ADDENDUM

TO: ALL PROPOSERS UNDER REQUEST FOR PROPOSAL (RFP) NO. 16-500421

ADDENDUM NO. 1

RFP No. 16-500421 for "Design and Construction of New Tag Office" is hereby modified as follows:

SITE SURVEY - "EXHIBIT A"

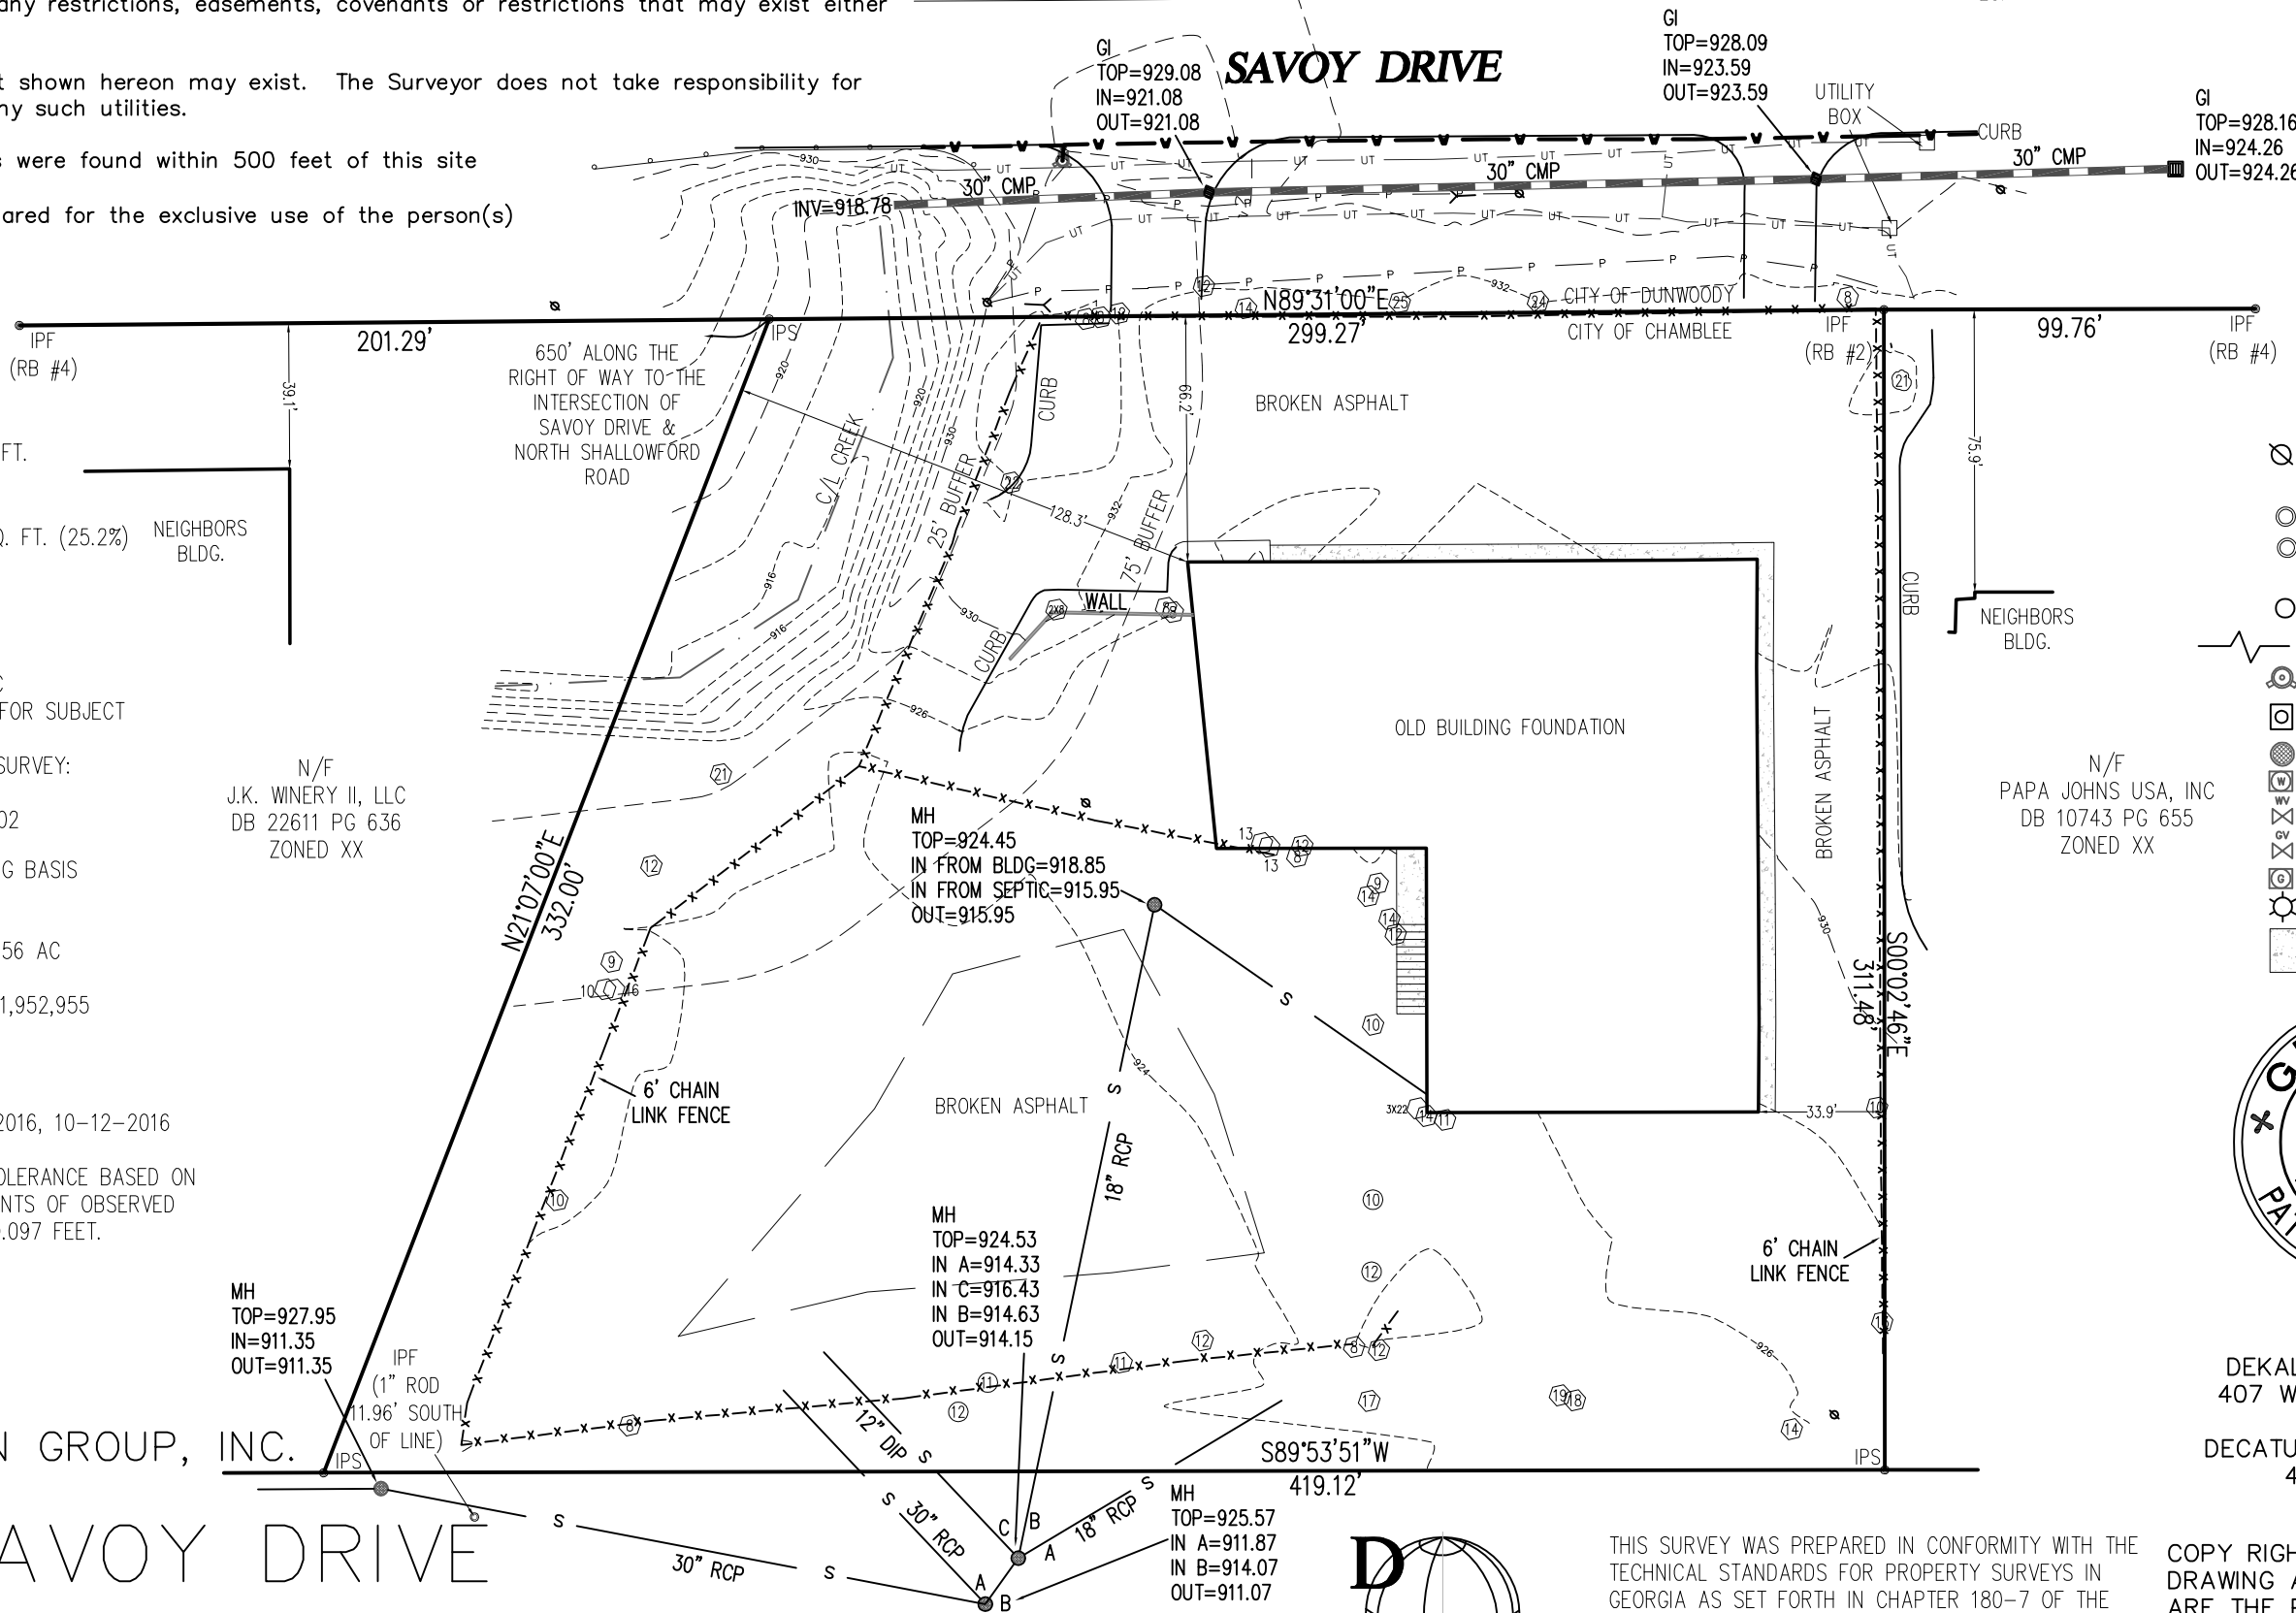
H. **Question** – Will county supply property boundary and topographic survey and if so in what format?

Answer – *Yes. See Site Survey attached hereto as “Exhibit A”.*
